Urgent SAFETY NOTICE

Scewo AG, Switzerland

- Scewo BRO V1
- Scewo BRO V1.1 (Basic UDI-DI: 7649992967BRWF)

Ref: FSCA-50

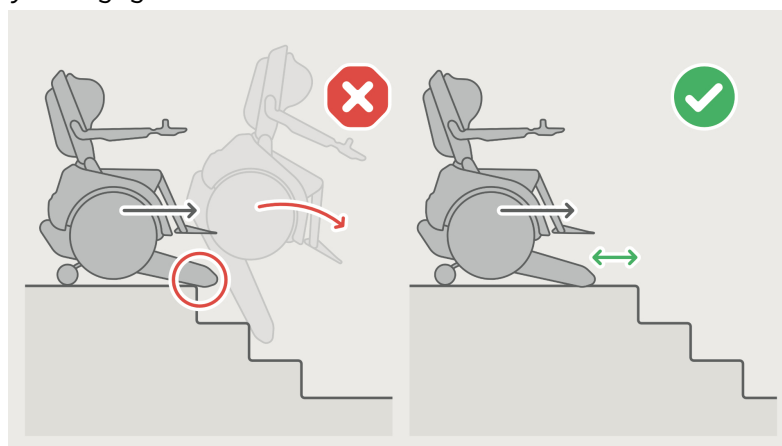
As part of the corrective actions, we would like to re-emphasize the instructions for use when you go **down** a single step with your BRO: for a step of 5 cm to 20 cm high, it must be overcome in **STAIR MODE**.

✓ BRO can drive over the ridge.

✗ Unfortunately, BRO cannot drive over the ridge.

This mode has to be chosen latest before the front of the tracks are over the edge of the step (in drive mode we recommend a minimum of 50 cm of safety distance to switch to stair mode).

Despite these software changes you should still ensure that the front of the tracks are not over the edge before you engage stair-mode to avoid such a situation at all:
